N1092A-01

Modification Recommended Service Note

N1092A DCA-M Sampling Oscilloscope (Single Optical Channel)

Figure 1 Updated overlay - should say 1.4 Vpp Max

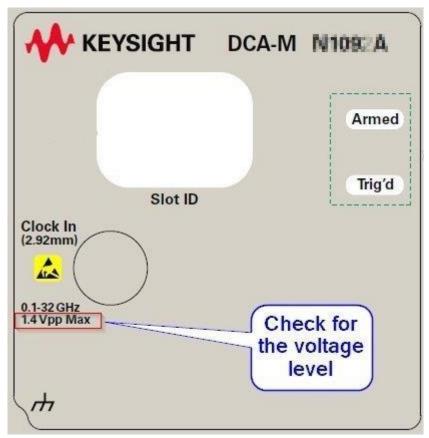
In May 2018, the clock's input port maximum signal voltage changed from 2.0 Vp-p (old value) to 1.4 Vp-p (new value). This is very sensitive circuitry and this change provides additional margin to reduce risk of damage to the instrument.

New instruments shipping after this change has the new left front panel overlay with this updated information, see Figure 1 below.

If the front left panel overlay shows 2 Vp-p (old value), remove the old overlay and replace it with the new overlay that shows 1.4 Vp-p (new value). If the customer has added any asset tags, or other customer information to the old left front panel overlay, it is recommended to send back the old overlay to the customer after it has been removed.
